**Presentation from  
Justice, Peace and Integrity of  
Creation Office of the Sisters of St.  
Vincent de Paul**

**BWXT Nuclear Energy Canada Inc.,  
Toronto and Peterborough Facilities**

Application for the renewal of the licence for  
Toronto and Peterborough facilities

CNSC HEARING  
INTERVENTION RE: BWXT  
LICENSE RENEWAL

Peterborough:  
CANDU®  
Fuel &  
Engineering

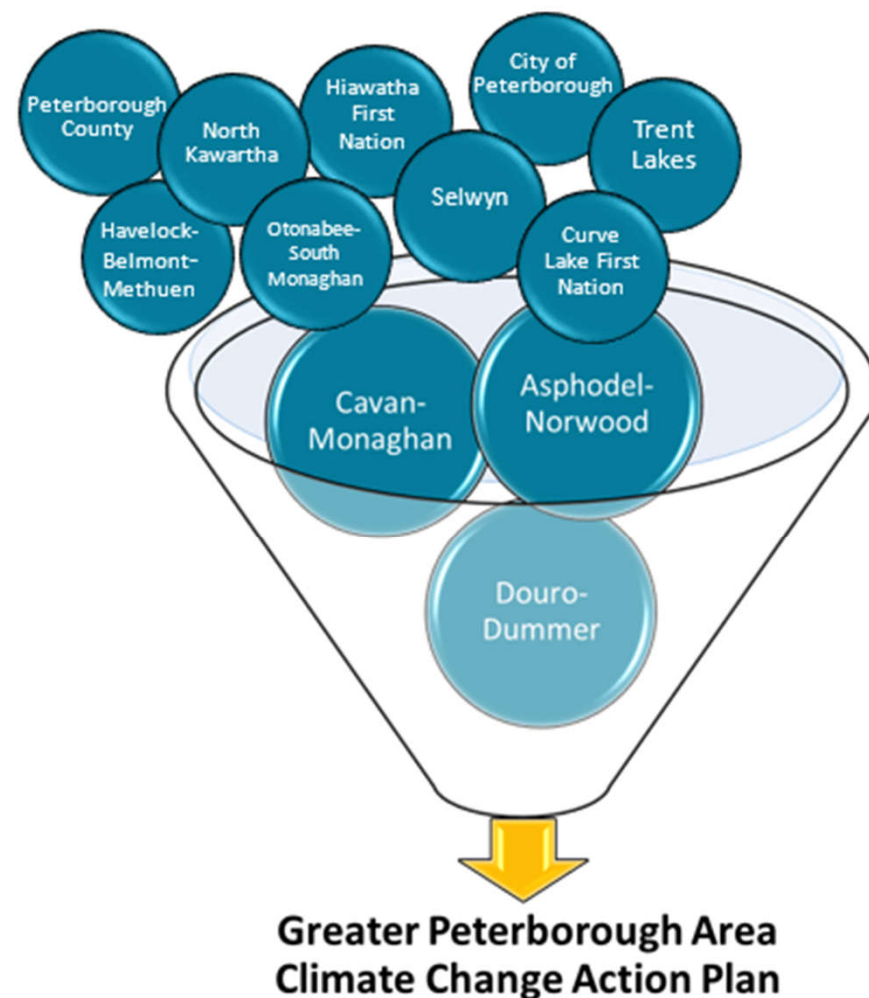
-the temperature, wind, and precipitation data in the ERA are from 1981-2015.

-this does not account for how the region's climate may change over the next 30 years

-the ERA in its entirety does not consider how climate change affects the project's possible
